AGENDA

CITY OF OPELIKA
HISTORIC PRESERVATION COMMISSION
April 11, 2024
4:30 p.m.
Meeting Chambers at Opelika Municipal Courtroom
300 MLK Boulevard

City of Opelika
Historic Preservation Commission
Staff Report

Old window location exterior-not drawn to scale

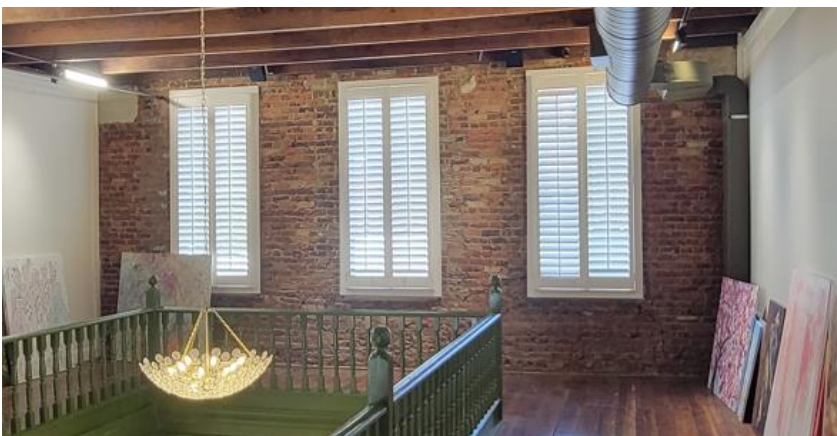
1. Install three (3) wood frame windows with Lexan polycarbonate glass on the right side of 2nd floor where previous windows have been bricked in. The new windows will not have grids and will be identical to the upper floor window on rear. All side windows will have 1.5-hour fire rated glass to meet safety code.

1. *Staff recommends approval to reinstall wood framed windows on upper floor where windows were previously to match existing upper floor window. New windows must be 1.5-hour fire rated on side elevations.*

Revised site plan showing single floor detached garage on main structure and separate residential unit in rear

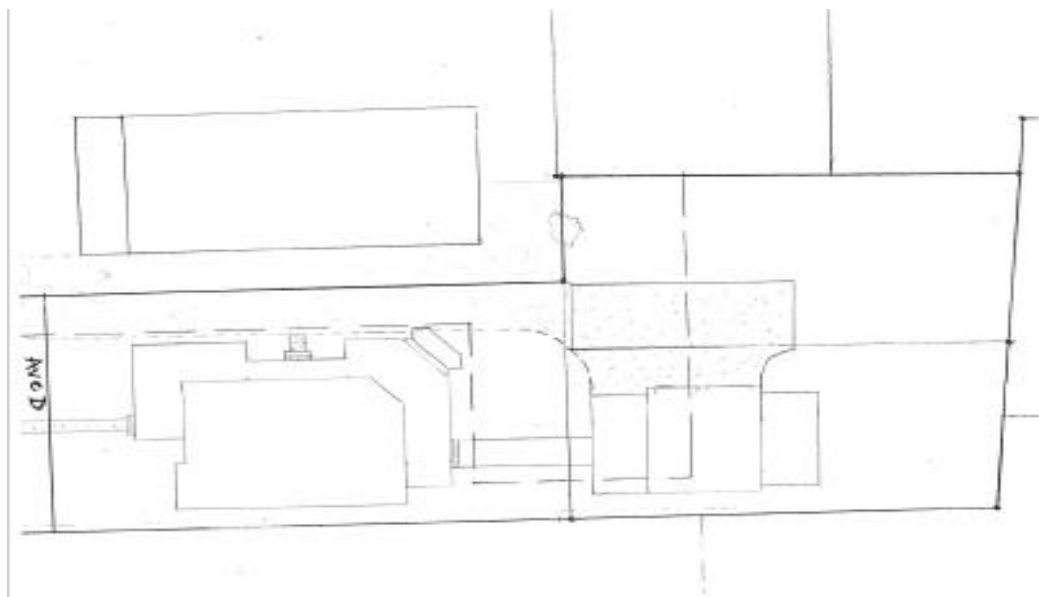
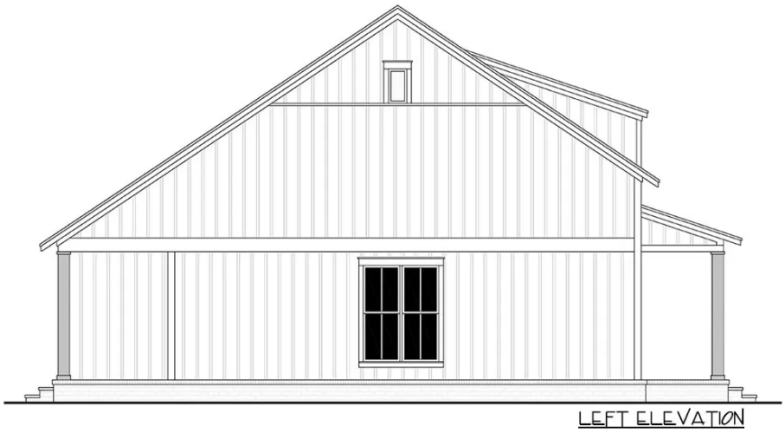
History: Applicant had single-family home with detached garage with second floor guest suite approved at the December 14, 2023, meeting. He now wishes to make the garage a single story and build a small unit in the rear on a separate lot.

- Varied roof pitches and window symmetry and configuration should be compatible with the rhythm of surrounding properties.
4. The Applicant will be required to move current lot lines. A formal site plan showing all setbacks meeting requirements should be provided and approved by the Planning Department.

Site Plan for house showing detached carport with storage closet at rear

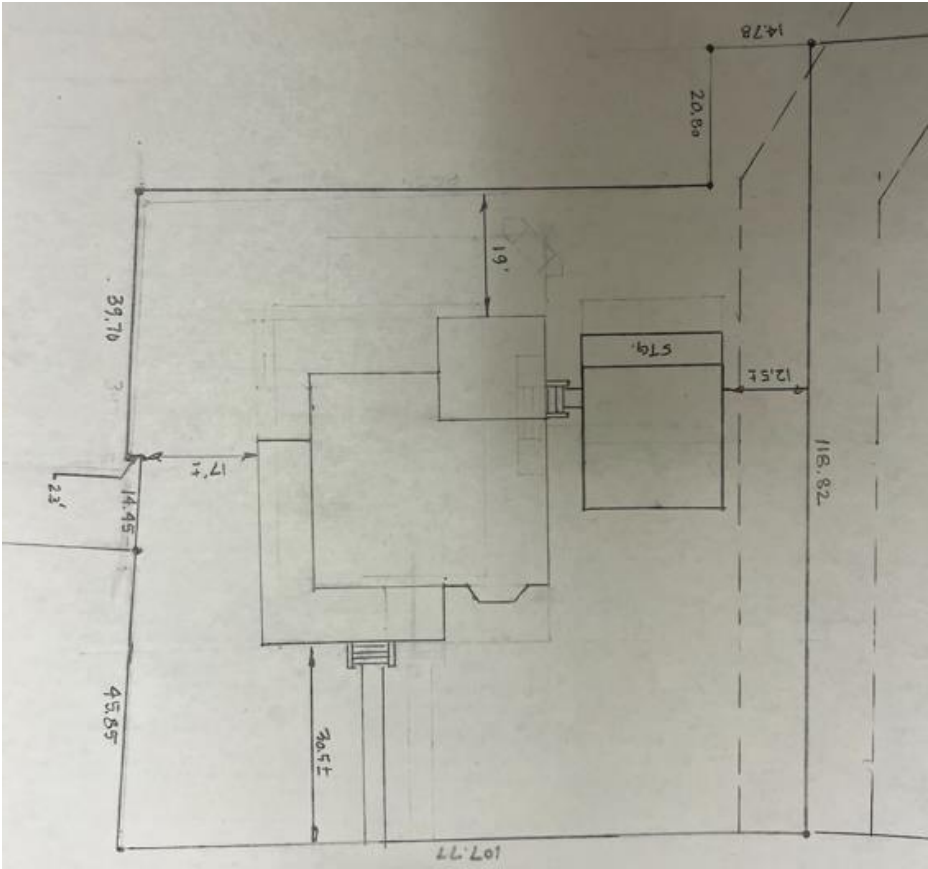
1. New construction two story single-family home with raised foundation, vertical board and batten with horizontal lap siding in gables, asphalt shingle roof, treated pine columns with stacked stone base, wood front door, steel panel door on rear storage area, double fir full view door on rear, Pinnacle clad double hung windows with no grids to match surrounding homes, treated pine porch decking and rails, and tongue and groove pine ceiling. Detached carport with side storage closet. The driveway will be gravel.
2. Changes to rendering include horizontal lap siding will be used in place of shakes in gables, asphalt shingle in place of metal roof, expanded rear dormers, and 22’ wide carport with storage closet at rear added to the side.

2. The commission should consider the following to blend with surrounding properties:
 - The setback of the property shall be in line with surrounding properties.

- Elevation shall be raised to be in line with surrounding properties.
 - Surrounding properties have horizontal lap siding with accents of vertical board and batten. This is the opposite of the proposed construction on this structure.

- Exposed rafter tails exist on properties within the district.
3. Staff recommends approval of exterior materials of vertical board and batten and horizontal board and batten, architectural shingle roof, wood columns, wood front doors.

4. Staff recommends windows be wood, wood with aluminum clad, or composite as approved on previous plans.
5. Site and landscape plan to be submitted and approved by the Planning Department.
